Epping to Thornleigh Third Track Proposal. Application number SSI 5132.

BULLETIN 4

Special Issue - Epping to Thornleigh Third Track Oppose this Project which will destroy Beecroft and Cheltenham A Submission Form for you to sign is on Page 4

What is wrong with the Epping to Thornleigh Third Track (ETTT) Proposal

Figure 5.5 Artist's impression of new elevated concourse at Cheltenham Station looking south from The Crescent (indicated circle)

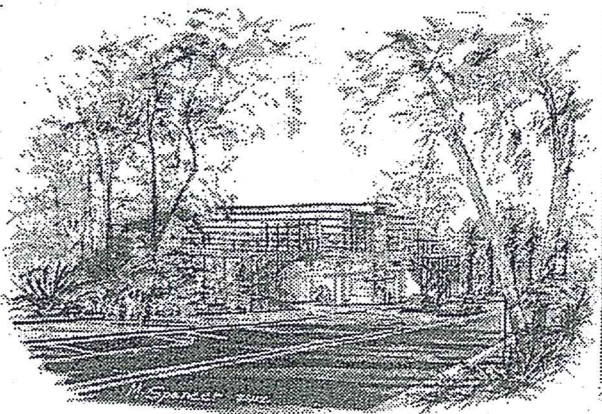
The ETTT proposal imposes a two storey, 13m high, railway concourse at Cheltenham to be positioned near the entrance to the current car park. It will have lift and stair access to all platforms, a bus bay and taxi rank. The indicative design shown in the EIS is a glass and steel structure. This is totally inappropriate for a Heritage Conservation Area and indicates that the designers either ignored or were unaware of the HCA. The only time buses come to Cheltenham Station is when they are replacing rail. There has never been a taxi rank at Cheltenham, nor any need for one.

The EIS considers that this huge structure is *'unlikely to have significant impacts on the heritage values'* of the houses opposite, mainly because some of them will be screened by vegetation.

Figure 5.6 Cross-section and elevation - New Cheltenham Station concourse building
Note: Indicatively added to future design

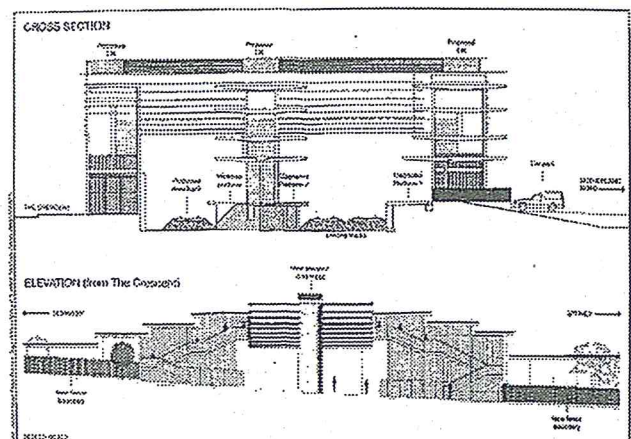
- The proposed redevelopment of Cheltenham Station shows no regard for the HCA. The visual impact of the proposed 13m high glass and steel concourse is totally unacceptable in this HCA.

Figure 5.3 Future Cheltenham Station layout

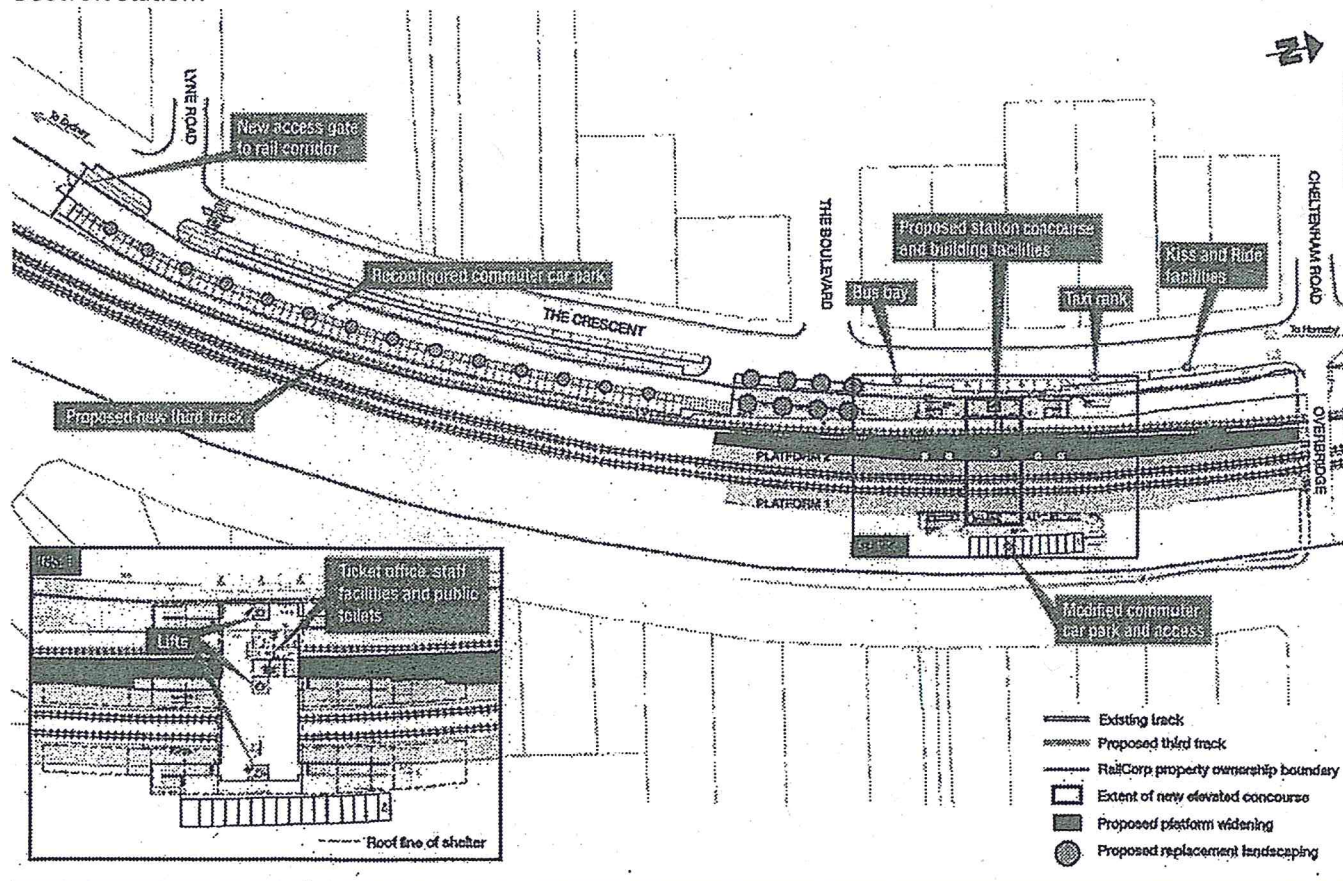
The car park on the western side will be extended almost to Lyne Road which will increase walking distance and impact on the Cheltenham Recreation Club. Parking in The Crescent adjacent to the station is removed.

Rock will be removed from the cutting under the western side of the road bridge which will be strengthened.

Why is this work proposed for such a quiet station when little enhancement is proposed for the much busier Beecroft station?
